Correction: CO₂ decomposition in a packed DBD plasma reactor: influence of packing materials

Correction for 'CO₂ decomposition in a packed DBD plasma reactor: influence of packing materials' by Debjyoti Ray *et al.*, *RSC Adv.*, 2016, 6, 39492–39499.

Fig. 3 Lissajous figure for DBD reactor as a function of voltage.

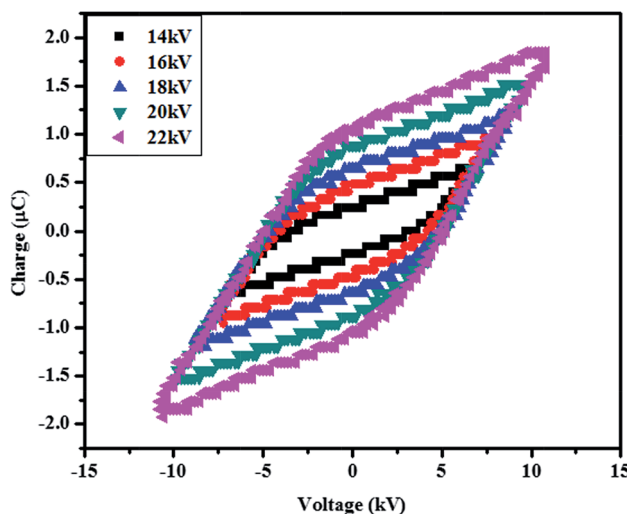
Fig. 3, 4, 5 and 6 should be replaced with the following figures:

Fig. 6 Total charge transferred by the micro discharges per half cycle as a function of applied voltage (gas flow rate: 20 mL min^{-1} ; without dilution; frequency: 50 Hz).

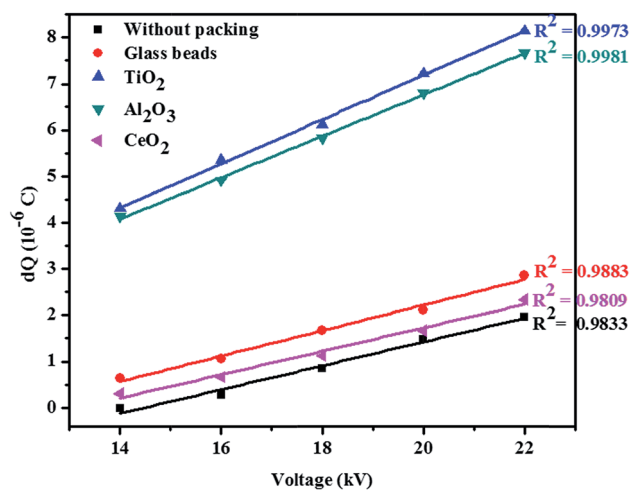
"It is known that dielectric packing improves the electric field strength, due to which more charge will be transferred to the microdischarges.⁶ Fig. 6 shows the total charge transferred by the microdischarges per half cycle for various packed bed DBD configurations. For a DBD reactor without any packing, the charge transferred was only between 0.015 μC and 1.96 μC , corresponding to the voltage variation between 14 to 22 kV, respectively. Under the same experimental conditions, 4.31 μC to 8.14 μC was transferred for TiO₂ packing. Porous alumina packed DBD showed a slightly lower charge of 4.14 to 7.67 μC , at 14 to 22 kV, respectively, whereas, glass beads and CeO₂ packing showed the lowest charge transfer, between 0.31 to 2.86 μC . This observation can be explained based on the high dielectric constant (85) of TiO₂ beads and alumina (9.1), due to which the strength of microdischarges will be higher for TiO₂ than other packing materials.^{33,34}"
